SANDY SPRINGS
GEORGIA

P&Z STAFF REPORT

Board of Appeals Meeting, September 7, 2022

Case: **V22-0022 – 1450 Northwold Drive**
Staff Contact: Helen Owens (howens@sandyspringsga.gov)
Report Date: July 27, 2022

SITE PLAN (received August 1, 2022)

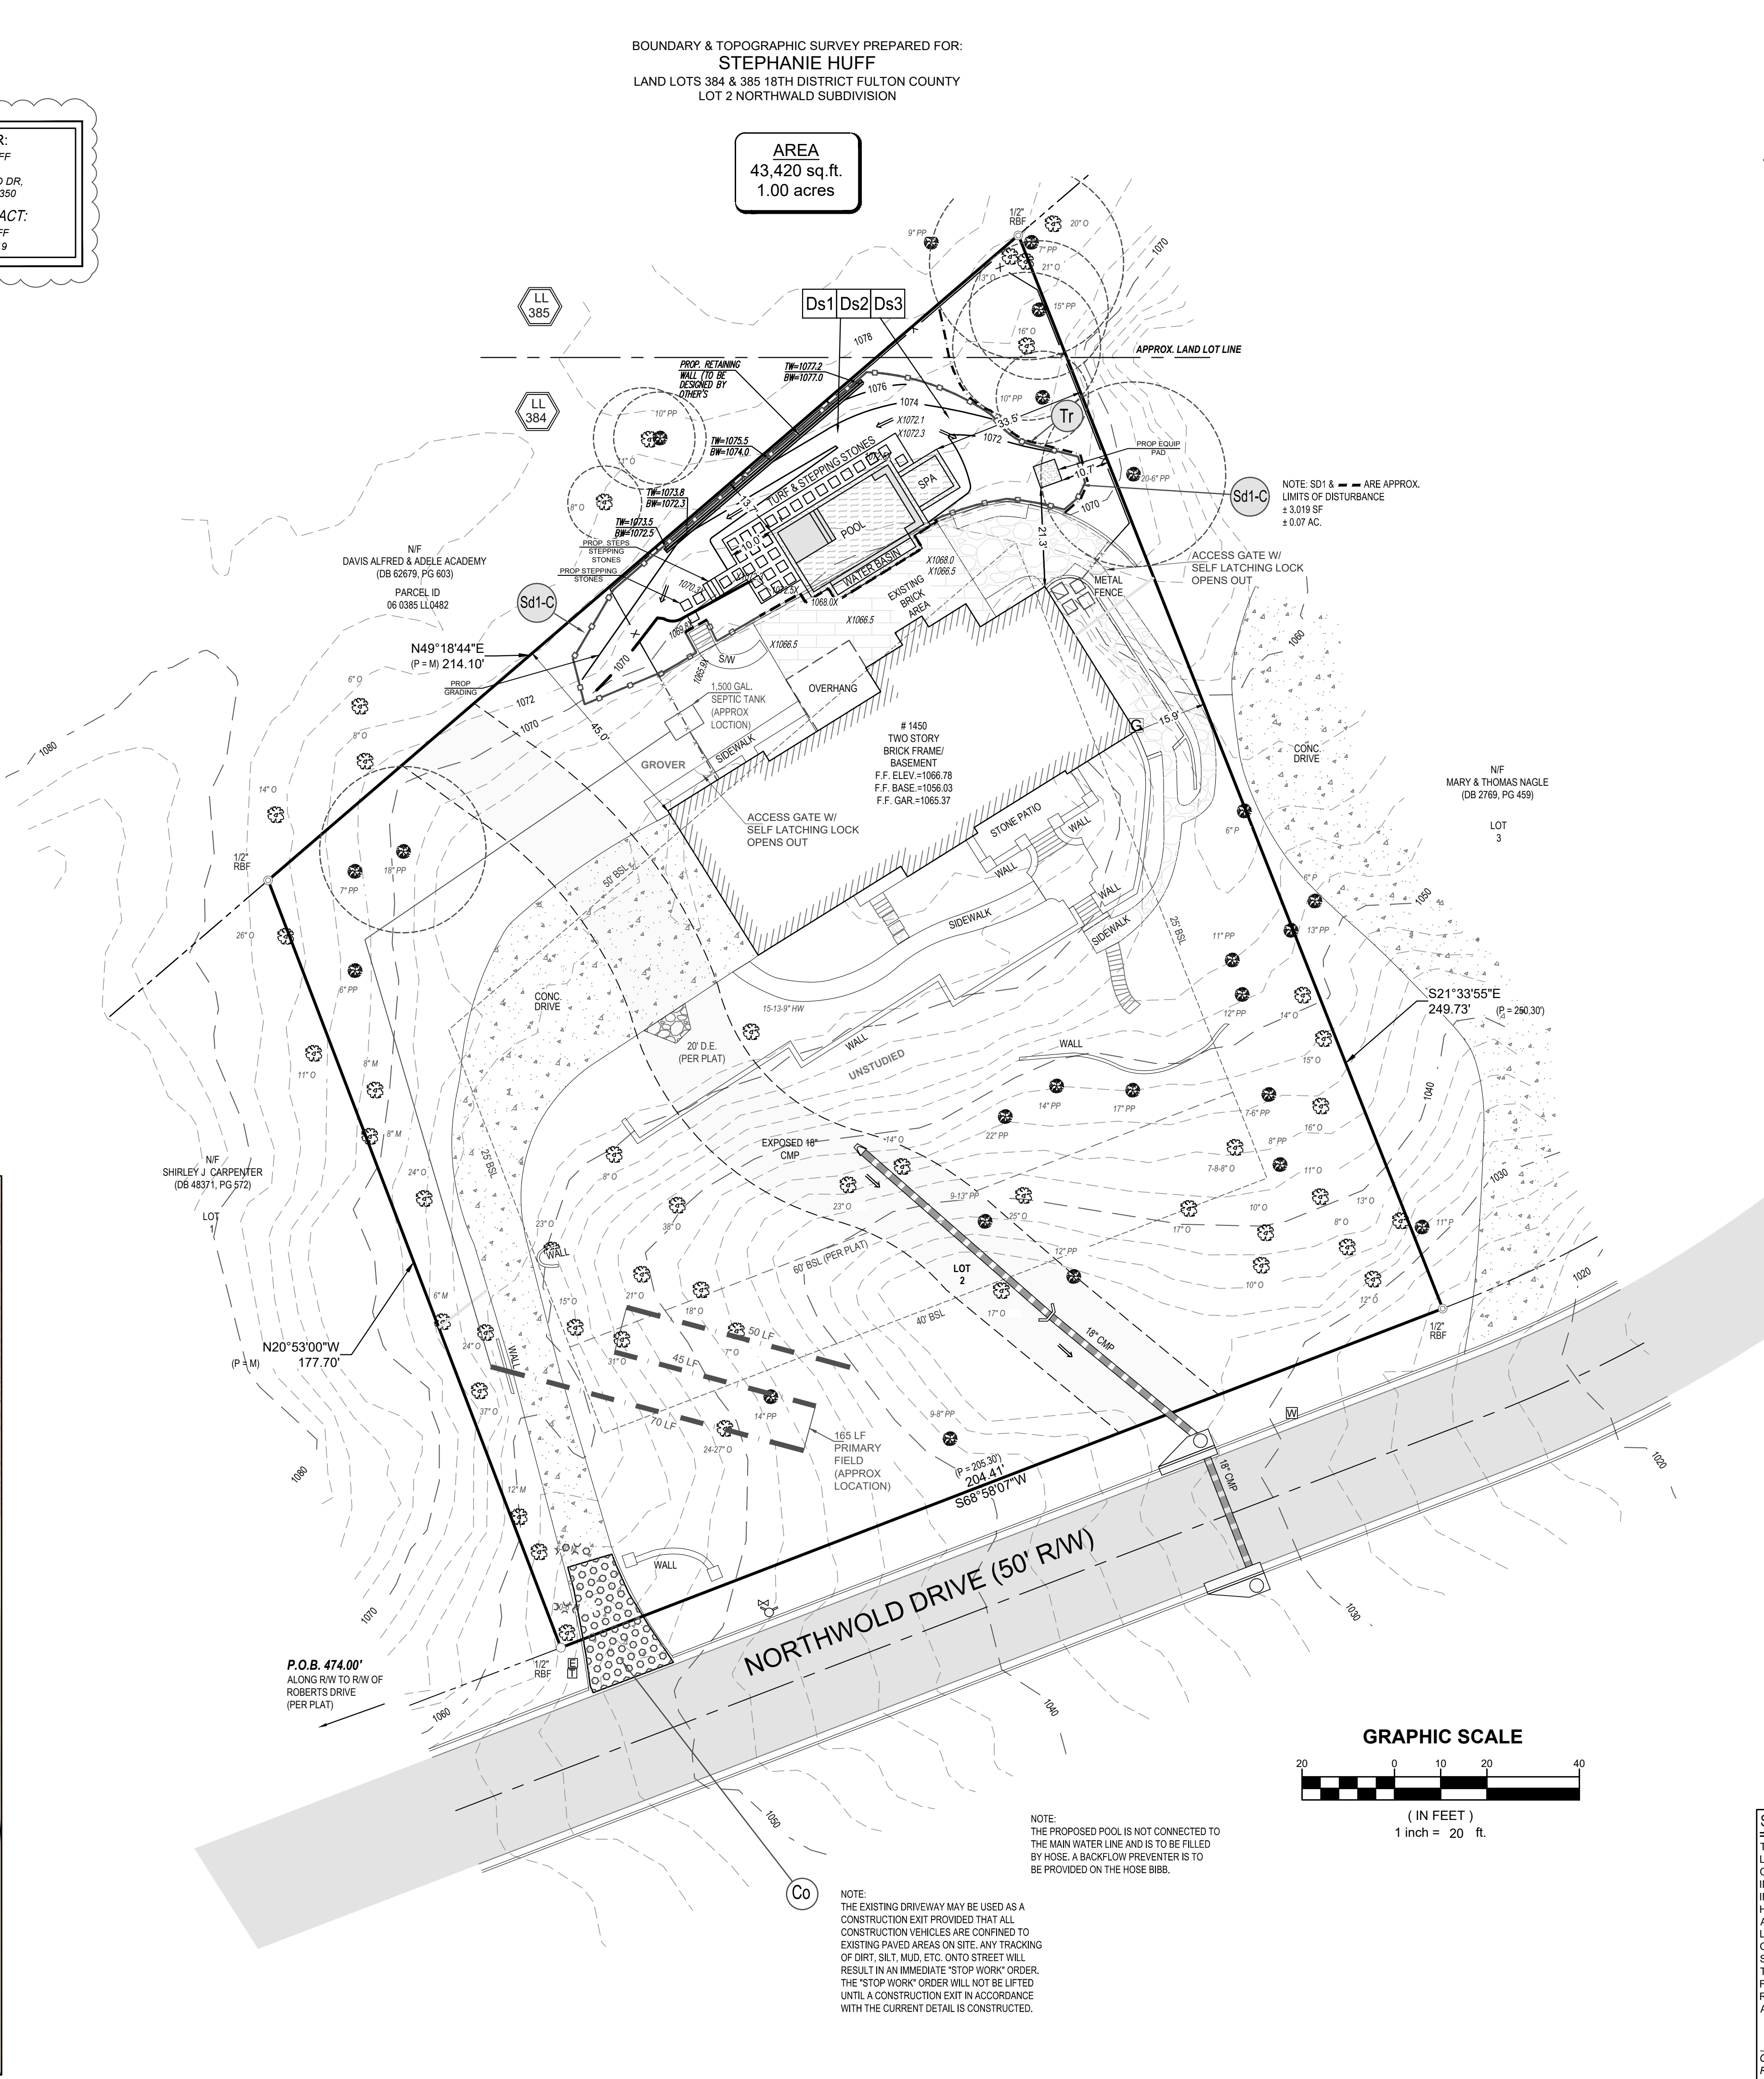
As illustrated on the previous page, the applicant seeks to install a pool within the northern rear portion of their lot. The pool would be located behind an existing brick patio which buffers part of the rear footprint of the home. A gentle to moderate slope from the patio retaining wall to the property line creates a significant enough elevation change that a retaining wall be required to create the needed flat area surrounding the pool as proposed.

Additionally, the applicant proposes to locate the pool equipment within the rear and side setbacks, which also requires a variance. Though there are certainly few options in terms of space for mechanical equipment within the buildable area at the subject site, there is space at the northern face of the northeast corner of the house. Beyond this location, much of the house footprint is directly bounded by or even encroaching into the rear and right-side common lot line setbacks.

Staff in its analysis added some illustrative measurements overlaying the site plan to help determine if the proposed pool and decking area could be located somewhere else in the rear yard without adjusting any proposed dimensions. It is Staff's opinion that the applicant could integrate the pool and decking area into the existing developed area (brick patio) and avoid needing to request a variance.

Staff determined the pool and decking area to be approximately 25' in depth. From the Grading setback line to the nearest point of the footprint of the house, the depth is no less than 30'. Staff believes this illustrates that there is ample space to achieve the same size pool and surroundings, within a Code conforming set of parameters. Staff also realizes that moving the proposed pool location would likely take away the implied aesthetics with the infinity wall lining the existing patio area. And facing the home. We would view this to amount to more of an inconvenience however, and not extraordinary or exceptional, or proving a hardship.

Keep in mind that if this variance gets approved and a permit is submitted, the critical root zones of the trees will need to be represented at 1.25' per 1" of diameter. They are currently shown at 1' per 1" of diameter. It does not appear that any surrounding trees will be significantly impacted.

There appears to be sufficient space to the back right of the house to locate a pool within the allowable grading and retaining wall setbacks.
